ADDRESS: 2010 EDISON**APPLICATION NO: #23-8479****HISTORIC DISTRICT: BOSTON-EDISON****APPLICANT: CLIFFORD TERRY****OWNER: DEBORAH VINSON****DATE OF STAFF SITE VISIT: 7/18/2023****DATE OF PROVISIONALLY COMPLETE APPLICATION: 7/10/2023****SCOPE: REPLACE BUILT-IN/BOX GUTTERS WUTH HUNG GUTTERS****EXISTING CONDITIONS**

Section drawing showing hidden location of built-in gutters

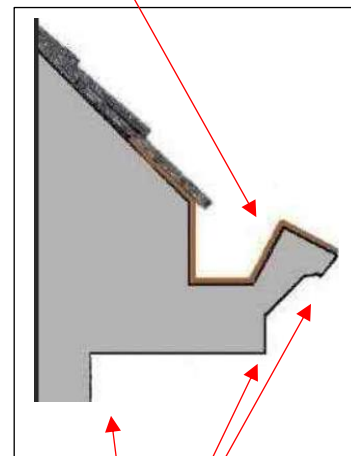
- Please see the below photos to note that the building retains its original built-in/box gutter system and historic metal box collectors at the front elevation. Modern k-style hung gutters have been affixed to the eaves/fascia at the side elevations. It is staff's opinion that the existing wood eaves/cornice at the front elevation's roof (to include the original wood integrated/box gutter system, dentilated fascia, and soffit) is a distinctive character defining feature of the home as they display decorative detailing associated with the Classical Revival style. Built-in gutters, hidden from view. Are a purposeful design element intended to prioritize the home's classical architectural character and detail at the eaves.

Original built-in /box gutters (not visible). See below section drawing

Classical detailing

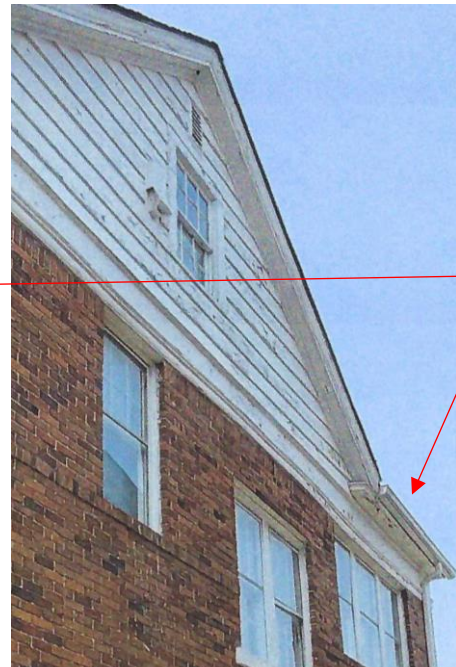
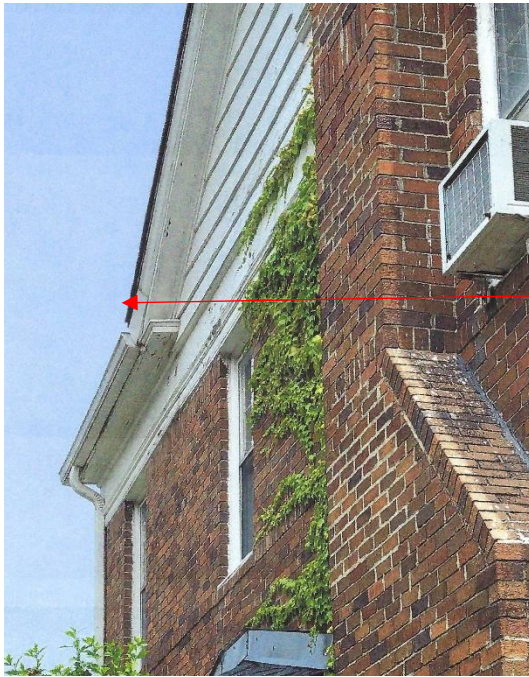
- Although the application has not specifically outlined how the new gutters will be installed at the front elevation, it is clear to staff that they will be appended to eaves in such a manner that will obscure or possibly lead to the removal of portions of the decorative stepped wood fascia and will change the geometry of the distinctive character-defining eaves/cornice. It is therefore staff's opinion that the proposed installation of new gutters at the front elevation does not meet the Standards, as these elements are distinctive character-defining features.

The submission does not indicate that the original built-in gutters are deteriorated beyond repair/that their repair is technically or financially infeasible. Also, the proposed new K-style aluminum gutters proposed for installation at the front elevation will obscure or possibly lead to the removal of portions of the decorative stepped wood fascia and will change the geometry of the distinctive character-defining eaves/cornice. For these reasons, staff recommends that the Commission deny the issuance of a Certificate of Appropriateness for the installation of new gutters at the building's front elevation as the work does not meet the Secretary of the Interior's Standards for Rehabilitation, in particular Standards #s:

Applicant photos

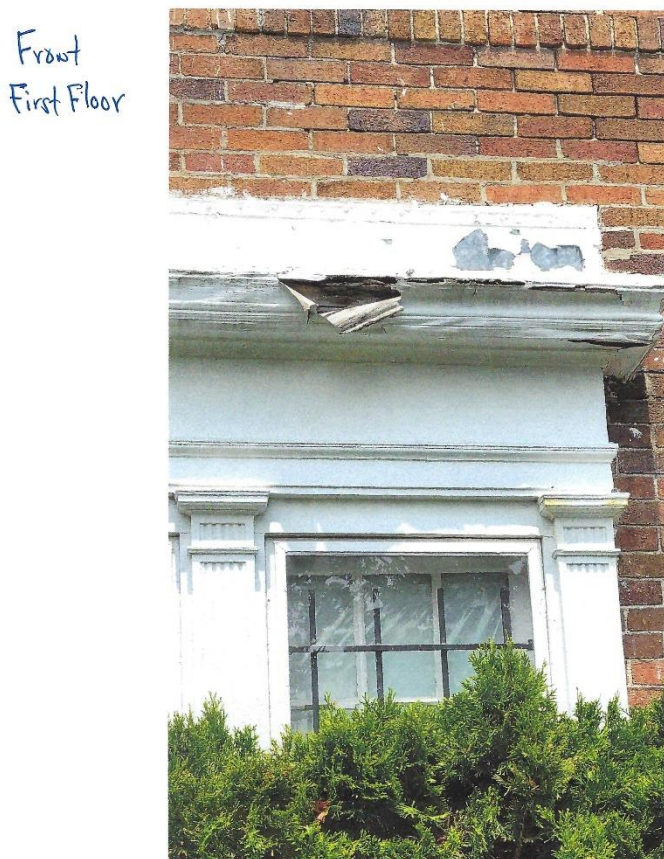
- The applicant included several photos of homes within the 2000 block of Edison which have conventional K-style aluminum hung gutters. Staff did conduct a field visit and confirmed the applicant’s assertion that most of the homes in the near vicinity of 2010 Edison do have modern aluminum gutters.
